Title: AUX FEED WATER PUMP P-38A MINIMUM FLOW RECIRCLINE ORIFICE

PLANT MODIFICATION NO.: 99-029*A

FINAL DESIGN DESCRIPTION MODIFICATION REQUEST 99-029*A

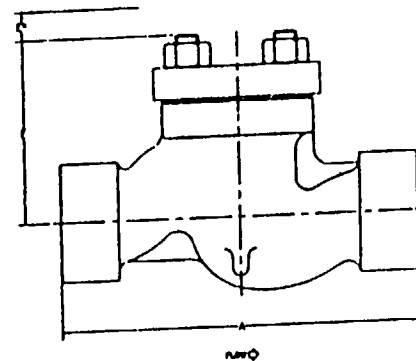
POINT BEACH TO
DRILL THESE WELLS.

NOTE: DRILL $5 \times \phi$
OF 61.007 (R33) THRO
HOLES TO BE DIAMETRIC-
ALLY OPPOSITE AND
EQUALLY SPACED
BETWEEN HOLES. IN
ROW ABOVE
